# SERVICE BULLETIN

M-874

Sept. 23, 1983

## TOUR-PAK FASTENER

Figure 1. Flat Washer Installation

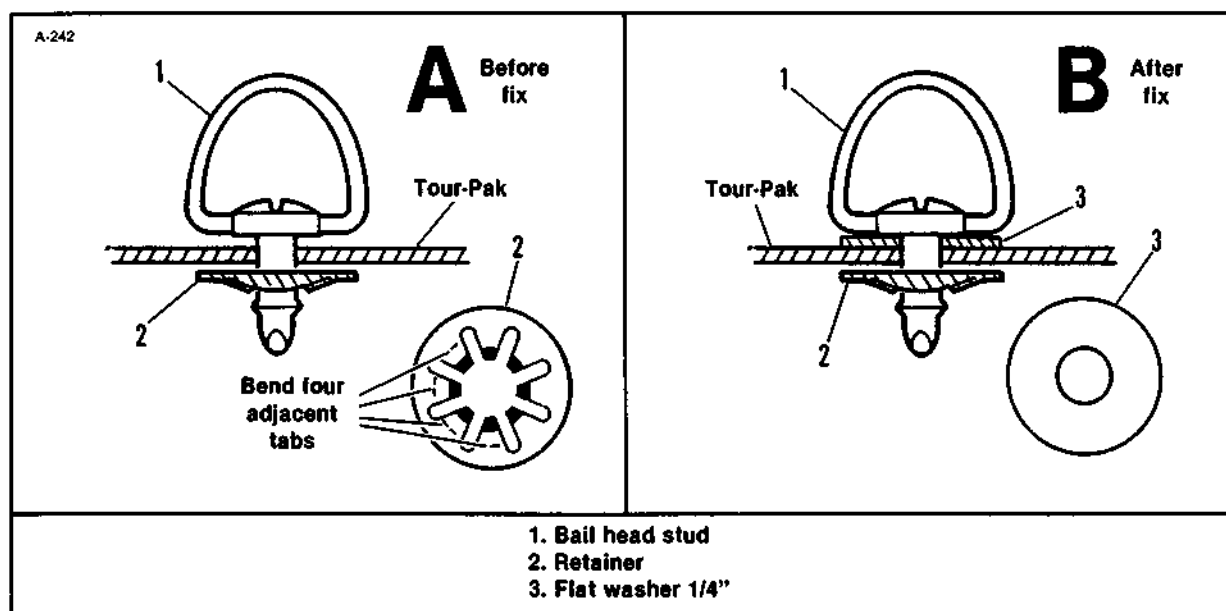
Earlier Tour-Pak installations did not have the reinforcement washer which increases retention of the stud in the receptacle detent. Tour-Paks that have quarter turn fasteners which do not hold the stud firmly in the receptacle can easily be fixed by adding a 1/4" flat washer beneath the head of the bail head stud.

1. With a pen knife or small screwdriver, bend four adjacent tabs on the retainer washer (2) to enlarge the inside opening. Retainer washer will now fall free.

2. Remove bail head stud (1).
3. Place an SAE standard 1/4" flat washer (3) over stud and reinsert stud through Tour-Pak hole.
4. With pliers, flatten tabs on retainer (2) closing the opening to original size.
5. Force retainer (2) flat side first, over shoulder of bail head stud (1) as shown in Figure 1.

*If there is any problem removing retainer, the part can be cut with a pair of side cutters and a new retainer installed. New retainers to replace those cut or damaged can be ordered under Part No. 90790-83.*
